Planning Commission Regular Meeting

Tuesday, January 21, 2025, 5:30 PM

PLANNING COMMISSION MEETING

Planning Commission Staff Report

1 ENTRY LEVEL - FLOOR PLAN
SCALE: 1" = 10'-0"

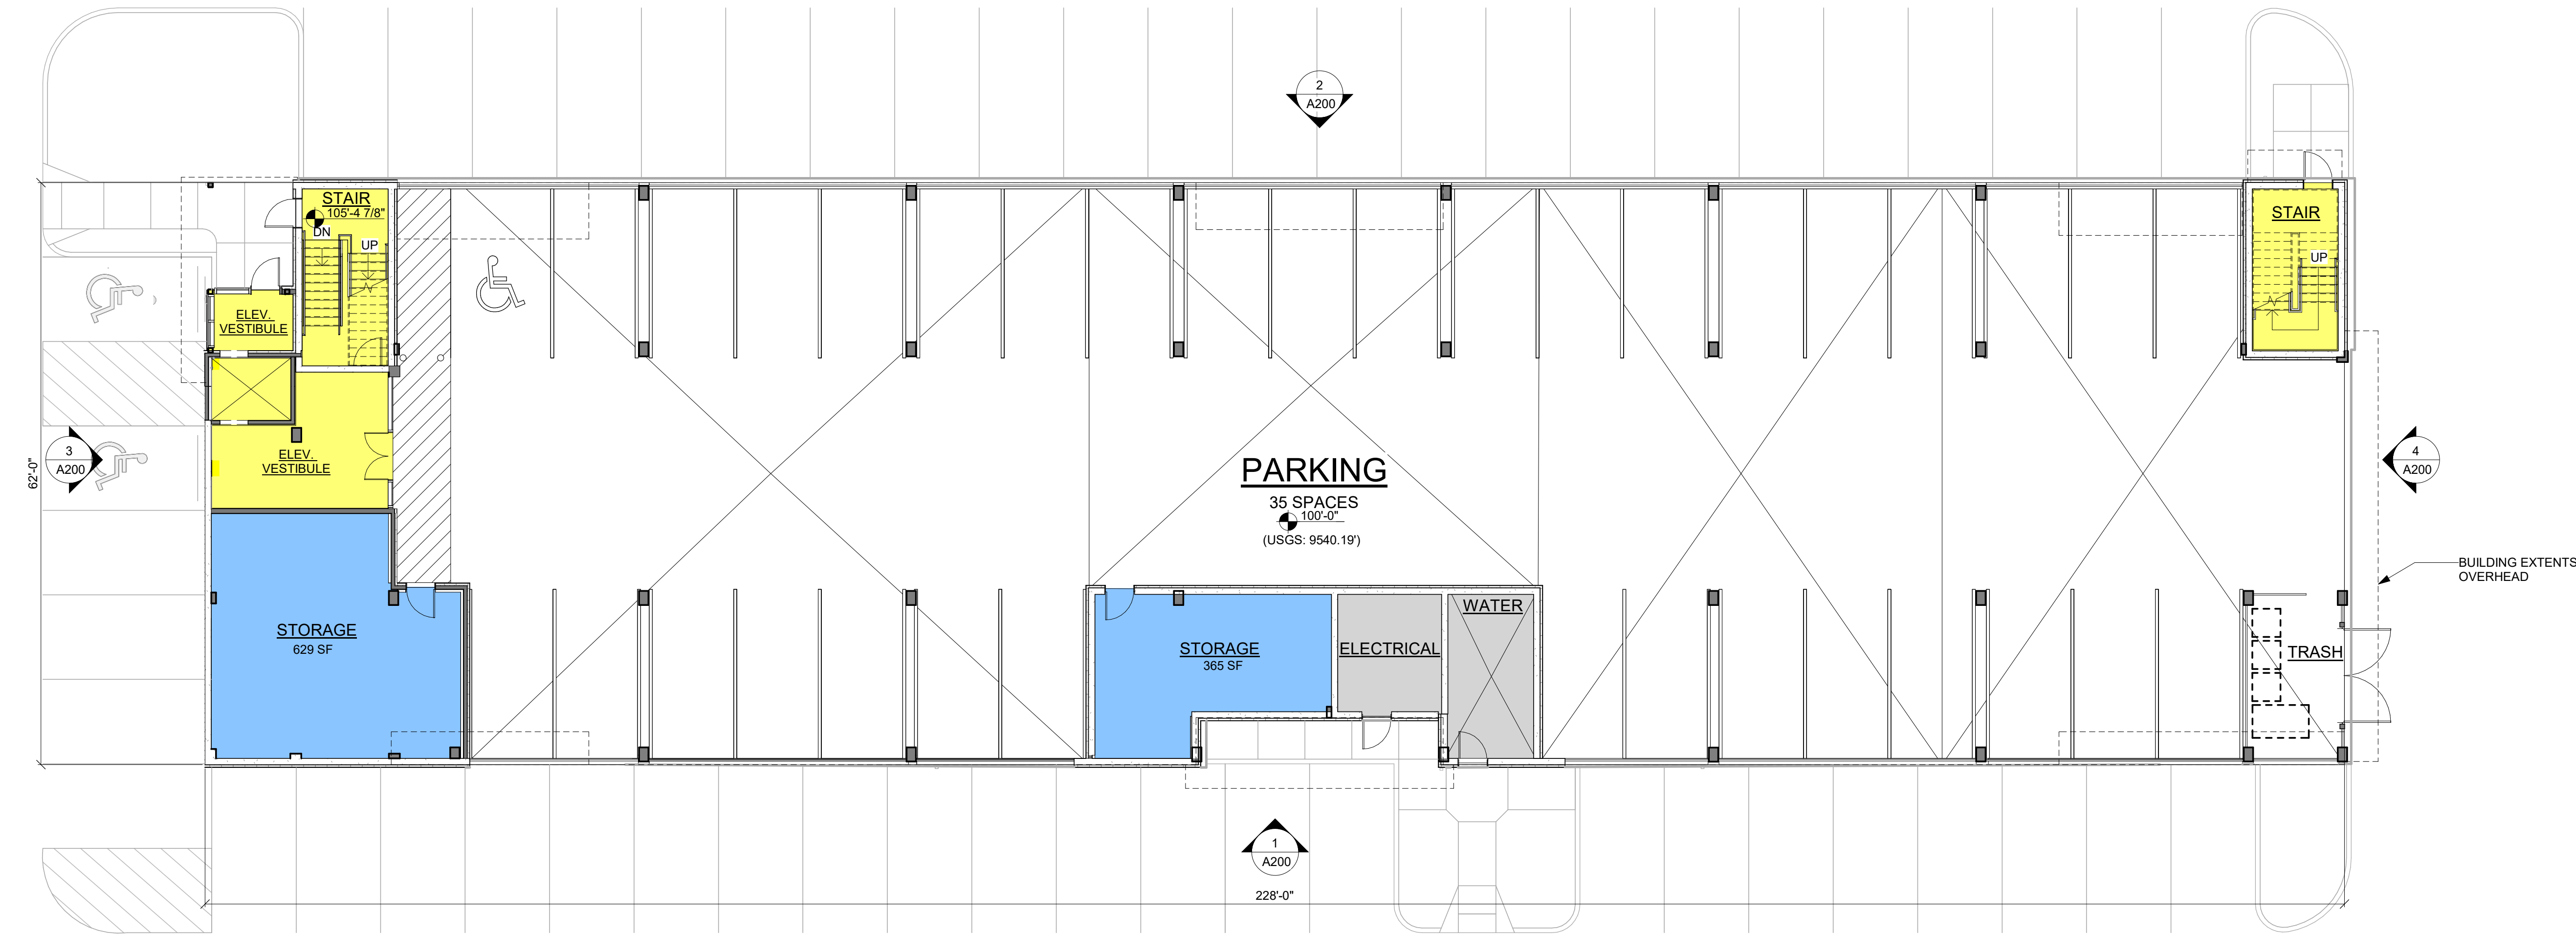
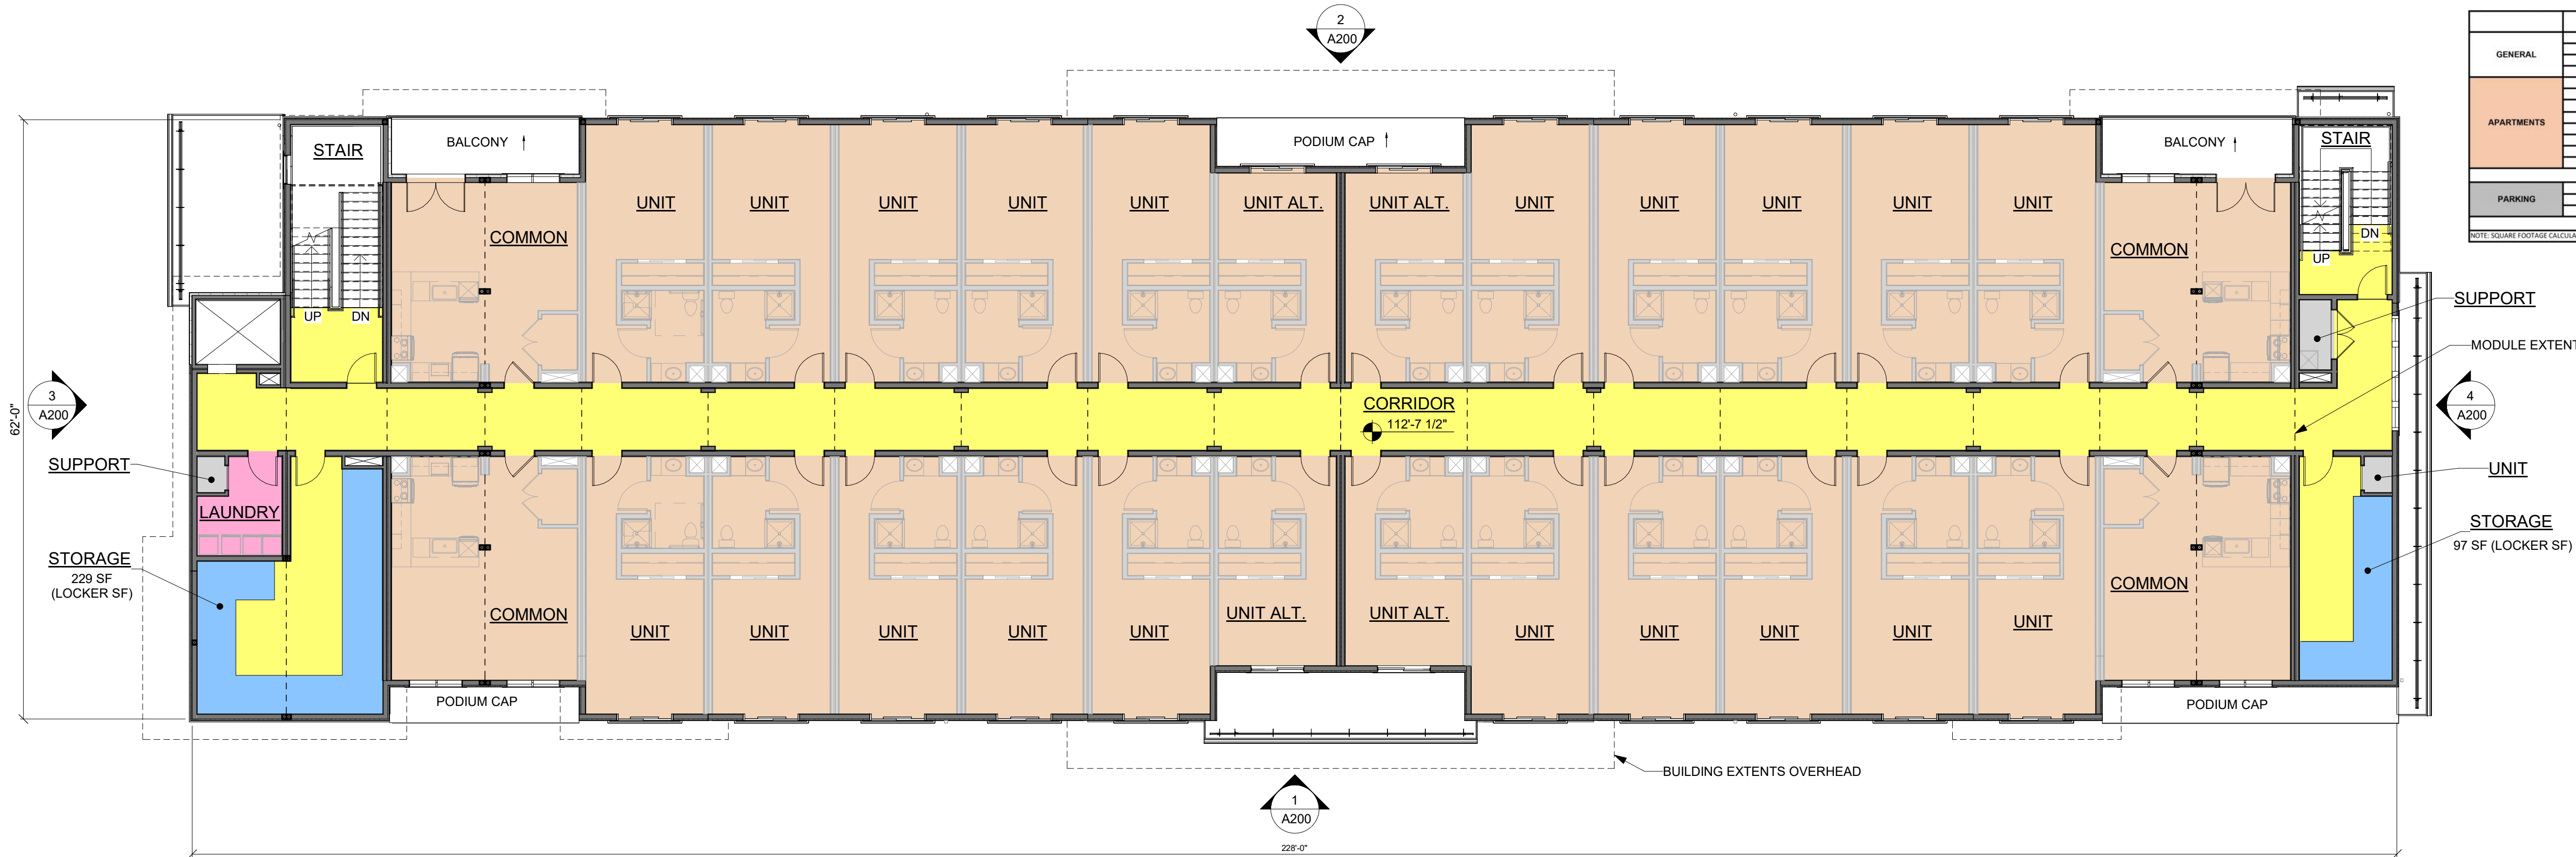
Interior unit layouts were revised to eliminate a redundant hallway on each of the residential floors. Units now open to a central shared hallway. This allows for greater privacy for individuals and creates slightly larger unit suites. The individual bed/bath suites now range from 291-357 sq. ft., as compared to the previous sizes of 237-257 sq. ft. each. Common area connections to common area adjacent suite bathrooms were also removed. Finally, the laundry facilities were moved from the common kitchen areas to a shared hallway accessible room on each floor. Moving the laundry may promote socialization by reducing noise in the shared common spaces. The Housing Department has reviewed and prefers the revised unit layout. Housing has restated that the private entrances to private bedroom and bathroom suites aligns with the agreed upon “studio” rental pricing for these units and is generally preferred by residents of facilities with shared common kitchens and lounges.
